Access Compliance Report

Public Rights-of-Way

(Pedestrian Signals)

Intersection ID: N/A	Main Street:	Cross Street: N/A	Location: N/A
ADA ID: 7FFB4157AB41	Signal Type: Two Push Buttons-APS	Overall Compliance: No	Severity Score: BTN 1:N/A BTN 2: N/A No BTN: N/A
Codes/Mitigation Info/Possible Solution		Field Measurements/Component Compliance

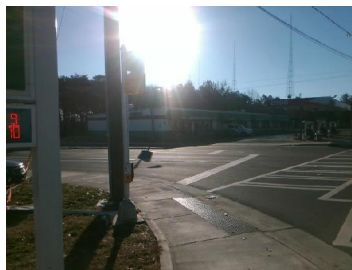
PROW/ADA: TMUTCD 4e.08, R404.2, R404.3, R406.2, R404.7.3

Compliance	Description	Data	Compliance	Description	Data
	Button Count	Button2	N/A	Distant to Additional Button (in)	N/A
	Additional Button Present?	No		Additional Button ID	N/A
N/A	Signal Buttons Required?	N/A	N/A	Additional Ped Posts Required	N/A
	How Many Ped Street Xings?	2		Located In An Island/Median?	No
N/A	B 1 Sign Present?	Yes	N/A	B 2 Sign Present?	Yes
Yes	B 1 Sign Purpose?	Yes	Yes	B 2 Sign Purpose?	Yes
Yes	B 1 Sign Lettering & Contrast?	Yes	Yes	B 2 Sign Lettering & Contrast?	Yes
Yes	B 1 Parallel To XWalk?	Yes	Yes	B 2 Parallel To XWalk?	Yes
Yes	B 1 PAR to Button?	Yes	Yes	B 2 PAR to Button?	Yes
Yes	B 1 PAR to XWalk?	Yes	Yes	B 2 PAR to XWalk?	Yes
Yes	B 1 Clear Floor Space?	Yes	Yes	B 2 Clear Floor Space?	Yes
N/A	B 1 FWD Approach?	Yes	N/A	B 2 FWD Approach?	No
N/A	B 1 FWD Approach Constrained?	No	N/A	B 2 FWD Approach Constrained?	No
No	B 1 FWD Approach Reach (in)	16.0	N/A	B 2 FWD Approach Reach (in)	N/A

N/A	B 1 FWD Approach Width (in)	N/A	N/A	B 2 FWD Approach Width (in)	N/A
N/A	B 1 FWD Approach Obstruction?	Yes	N/A	B 2 FWD Approach Obstruction?	Yes
N/A	B 1 FWD Approach Obstruction Dist (in)	14.0	N/A	B 2 FWD Approach ObstructionDist (in)	N/A
N/A	B 1 PARA Approach?	Yes	N/A	B 2 PARA Approach?	Yes
N/A	B 1 PARA Approach Constrained?	No	N/A	B 2 PARA Approach Constrained?	No
No	B 1 PARA Approach Reach (in)	12.0	No	B 2 PARA Approach Reach (in)	16.0
N/A	B 1 PARA Approach Width (in)	N/A	N/A	B 2 PARA Approach Width (in)	N/A
N/A	B 1 PARA Approach Obstruction?	Yes	N/A	B 2 PARA Approach Obstruction?	Yes
N/A	B 1 PARA Approach Obstruction Dist (in)	11.0	N/A	B 2 PARA Approach ObstructionDist (in)	11.0
No	B 1 Clear Floor Space Slope (%)	3.9	Yes	B 2 Clear Floor Space Slope (%)	3.8
No	B 1 Clear Floor Space XSlope (%)	2.1	Yes	B 2 Clear Floor Space XSlope (%)	1.1
N/A	B 1 PAR Slope (%)	2.8	N/A	B 2 PAR Slope (%)	4.1
Yes	B 1 Height (in)	34.0	Yes	B 2 Height (in)	34.0

Yes	B 1 Clear Xing Direction?	ClearlyMarked	Yes	B 2 Clear Xing Direction?	ClearlyMarked
	B 1 Crossing Direction	To SW		B 2 Crossing Direction	To S
Yes	B 1 DistanceTo XWalk (in)	24.0	Yes	B 2 DistanceTo XWalk (in)	0.0
No	B 1 DistanceTo Curb (in)	96.0	No	B 2 DistanceTo Curb (in)	96.0
Yes	B 1 Diameter (in)	2.0	Yes	B 2 Diameter (in)	2.0

Possible Solutions: Replace Signal Push Button With APS Button on New Post. Remove & Relocate Sign.
